CONDITIONS OF APPROVAL:

Engineering - PUD Plan Checklist

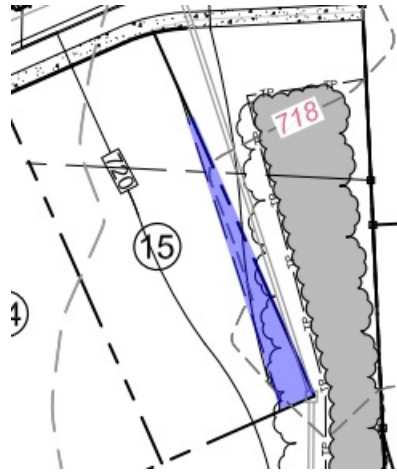
TIA identifies recommended improvements including WBL (with bay taper) & WBR/WBT lanes on Linden Isle Ln and NBR & SBL lanes on Lewisburg Pike. The SBL storage length shall be 150' per the on-call consultant review recommendation. The applicant shall update the development plan to incorporate the recommended lane additions. Lane improvements and all other TIA recommendations, including sight distance measurements, will be required to be included with the associated Site Plan for the Bushnell Development.

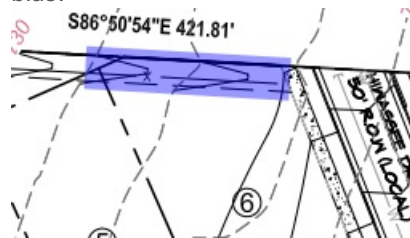
joe.marlo@franklinton.gov The following is a newcomment based on newinformation shown on the drawings.

Applicant shall provide a 10-foot drainage easement in the area highlighted below in blue.
